Assessment of Dam Safety Coal Combustion Surface Impoundments (Task 3) Draft Report

Duke Energy Corporation

Belews Creek
Steam Station

Walnut Cove, North Carolina

PROJECT NO.
 20085
 DATE: 10/2009
 FIGURE 3A

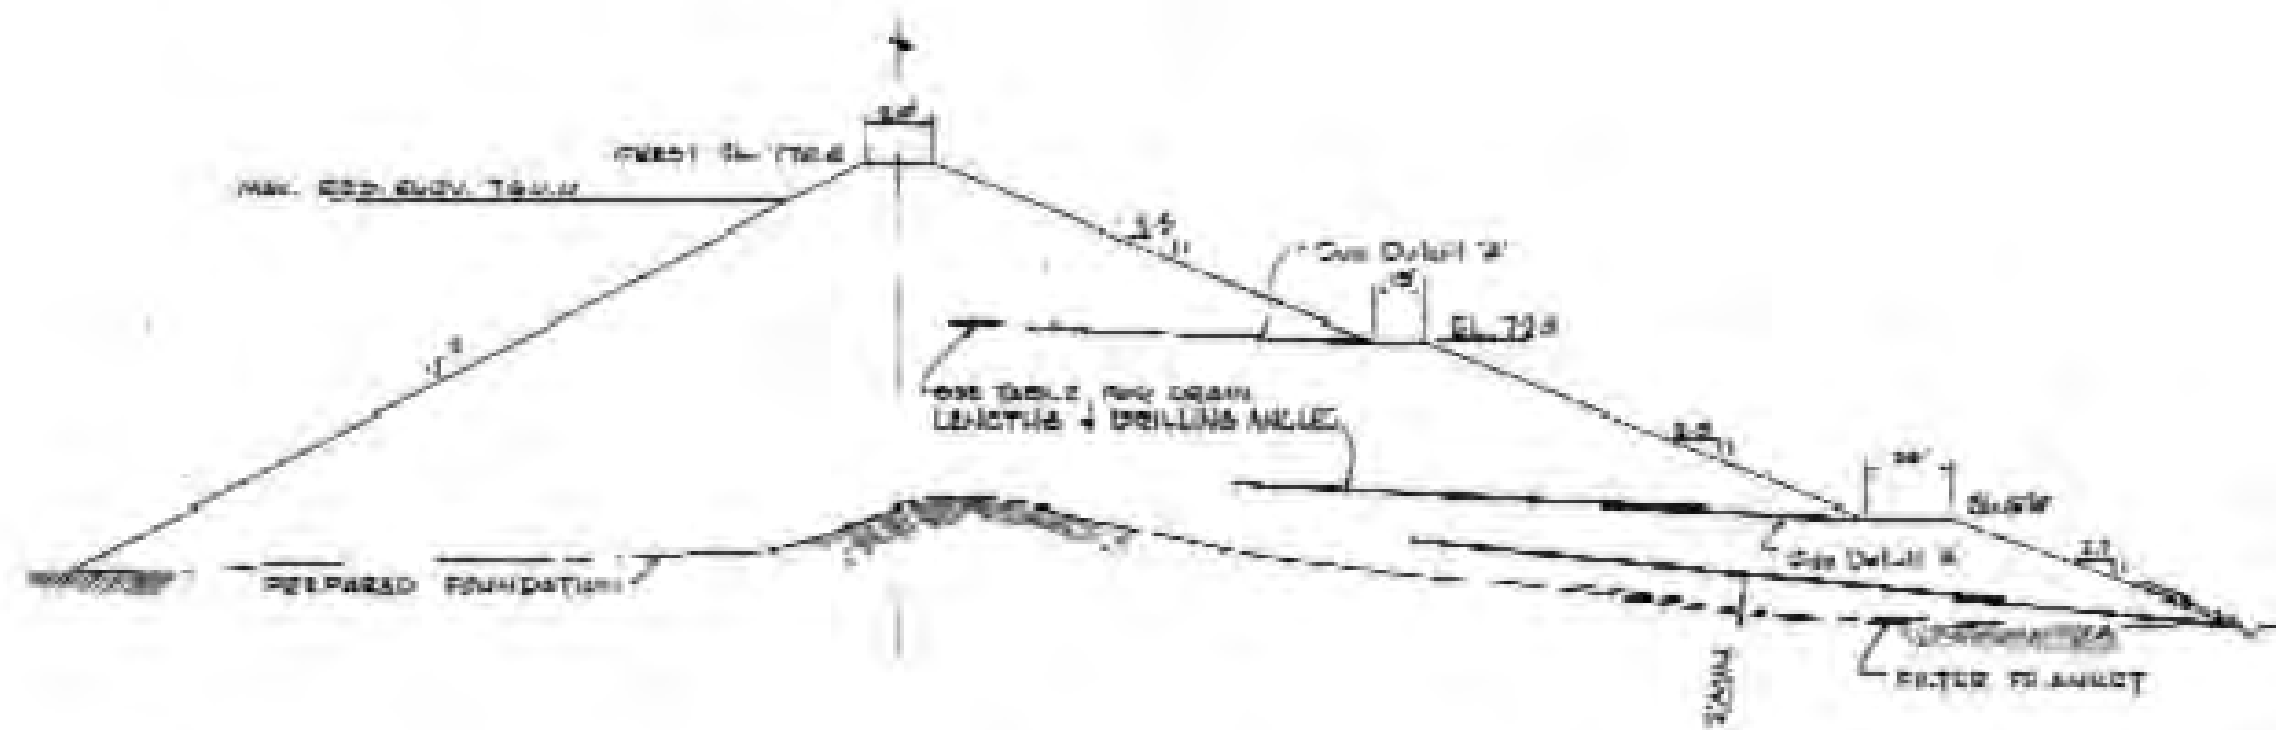
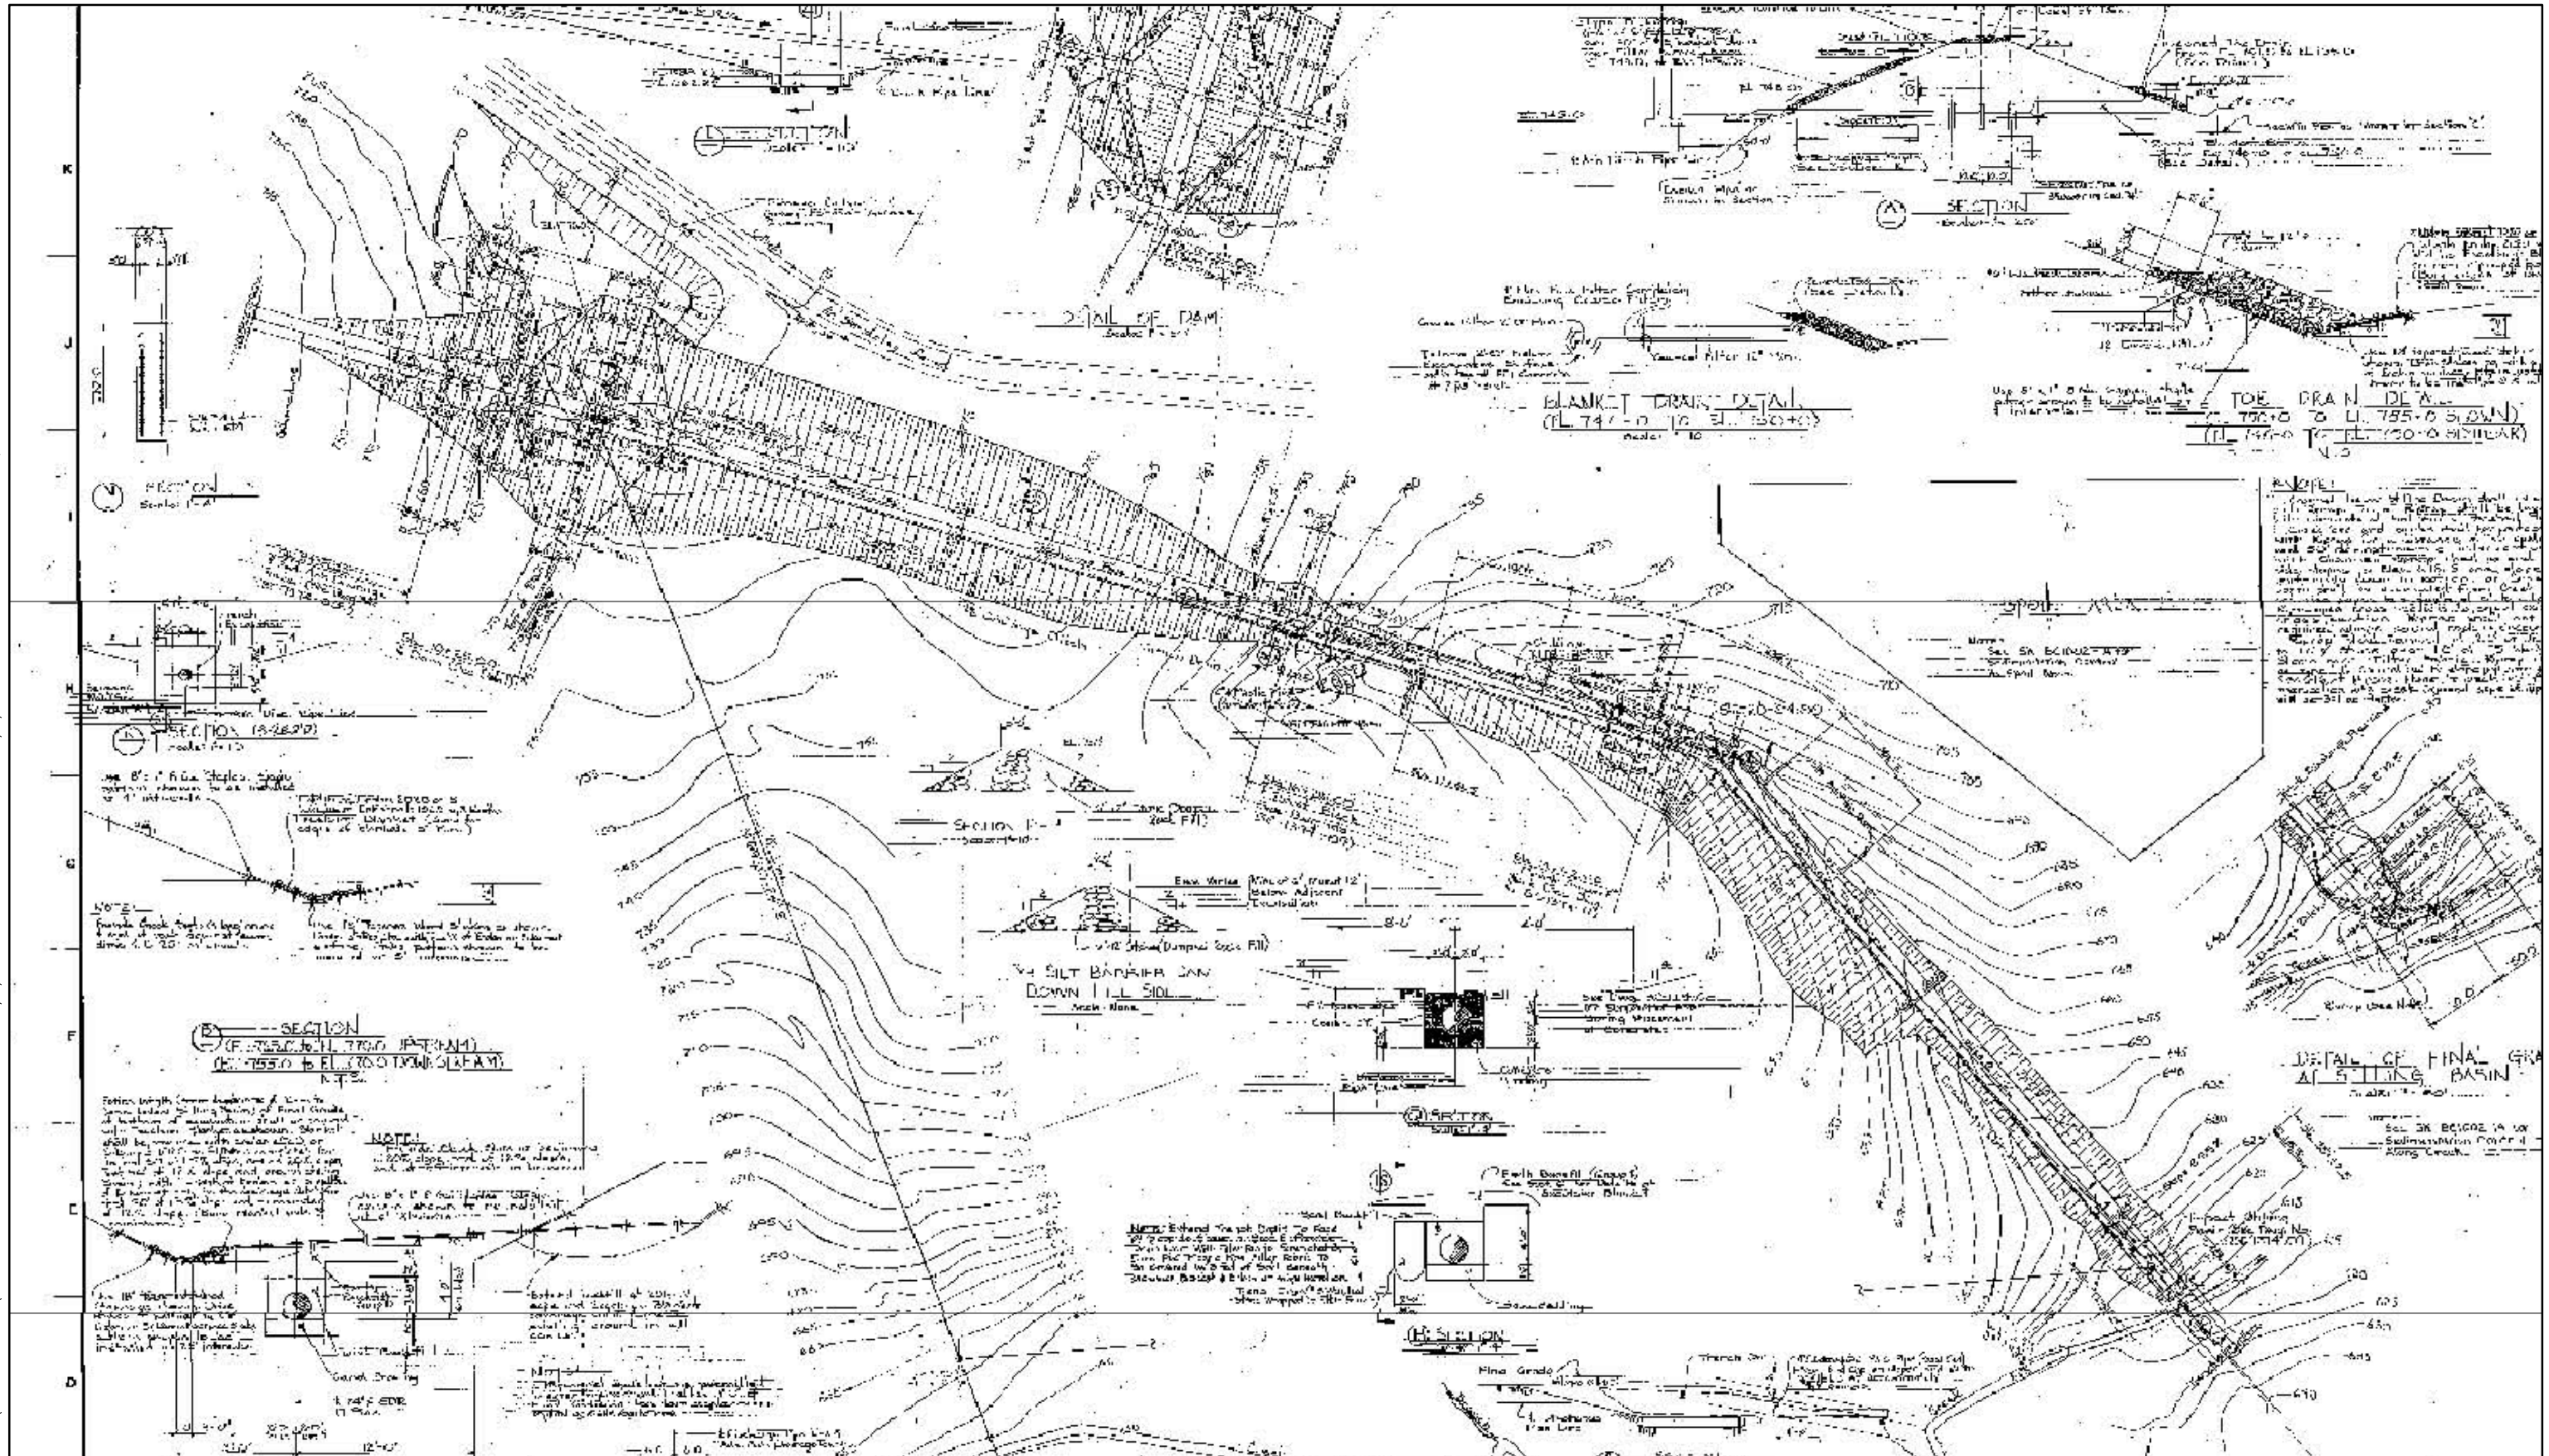
The downstream slope was reasonably uniformly graded at approximately 2.5 horizontal to 1 vertical as shown on Figures 3A and 3B and covered with appropriate grass vegetation, which had been recently mowed at the time of our site visit. Photos 12, 13, and 16 indicate the general condition of the downstream embankment. A damp area was noted at the toe of the slope in the vicinity of Station 10+00 which had soft soil and rutting caused by recent mowing activities. This area appeared to be related to the drainage from a horizontal drain and the removal of rip rap by maintenance staff. A localized area of instability was also noted adjacent to the drainage swale at the toe of the dam as shown in Photo 28. This area was also reported during the Seventh Five-year Independent Consultant Inspection.

<p>Drawing Copyright © 2009</p>  <p>Winners Circle, PO Box 5269 - Albany, NY 12205-0269 Main: (518) 453-4500 • www.ciacompanies.com</p>	DISCHARGE PIPELINE		PROJECT NO. 20085
	DUKE ENERGY BELEWS CREEK STEAM STATION WALNUT COVE, NORTH CAROLINA		DATE: 10/2009
			FIGURE 4

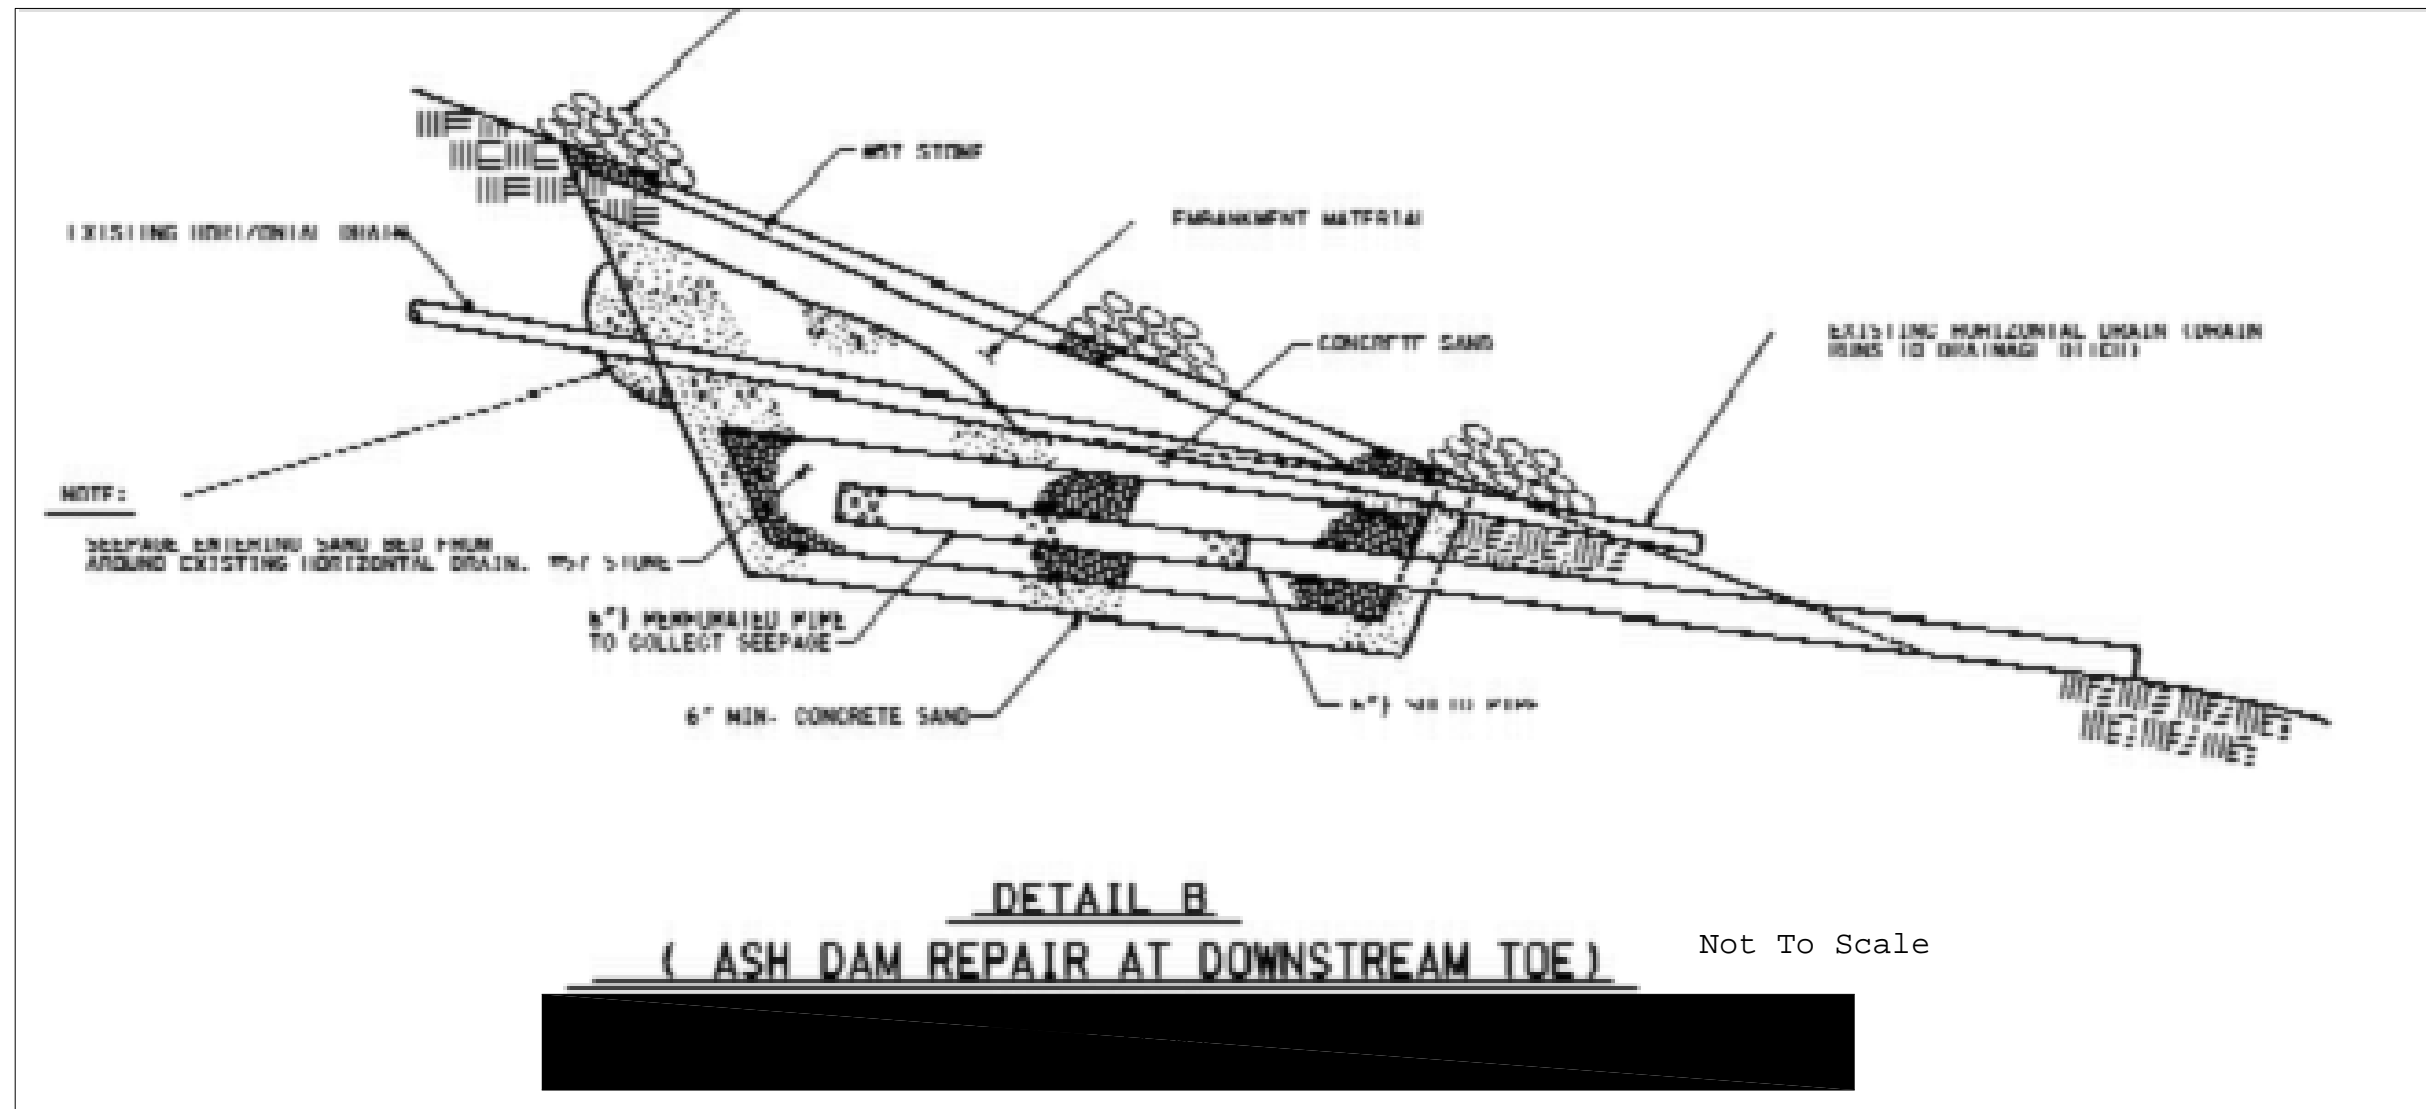
The construction drawings as shown in the cross section in Figure 4 indicate that the discharge pipe around the dike is a 24-inch SDR 17 pipe (smooth wall HDPE, 21-inch I.D.) that was installed as part of upgrades in 1984. The downstream end of the pipe terminates at Elev. 616
